Memorandum

December 9, 1991

Steve Ego

FPT sustained currents

Figure 1:

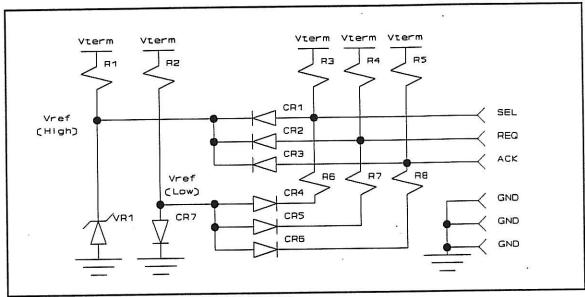
If this cannot be accomplished we have modified our regular FPT to a "Model C" configuration per your suggestion. In this configuration we have added current limiting to the clamp circuit. The results of this current limiting in a typical system installation are shown in this document. You will see that the sustained current now only reaches the 24 mA level. Yet, when you compare the wave shapes against the 220/330 and Boulay terminators, the FPT still outperforms them. FPT provides an additional 400 millivolts noise immunity. Quite impressive!

$R_6$ ,  $R_7$  AND  $R_8$  ADDED, 45.3 OHMS EACH
